THM 440-T4 HARSH DRIVE ENGAGEMENT

COMPLAINT: Harsh garage shift from Park/Neutral to Drive.

Figure 1

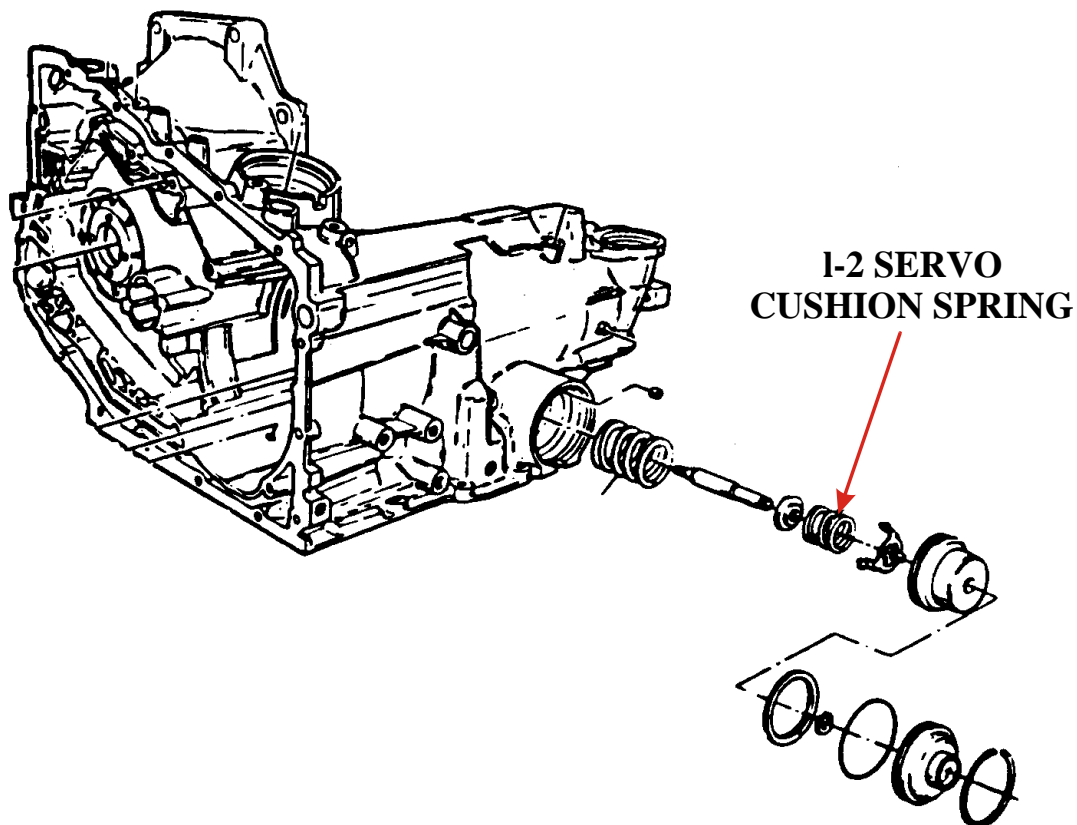
CAUSE: The cause may be:

1. Low vacuum supply to vacuum modulator.
2. Stuck modulator valve in case.
3. No. 12 checkball missing or off location.

CORRECTION: AFTER ALL OF THE ABOVE ARE ELIMINATED:
There is now available a new 1-2 Servo Cushion Spring. Replacing this spring should correct the harsh drive condition (See Figure 1).
Spring, 1-2 Servo Cushion (All).....8668123
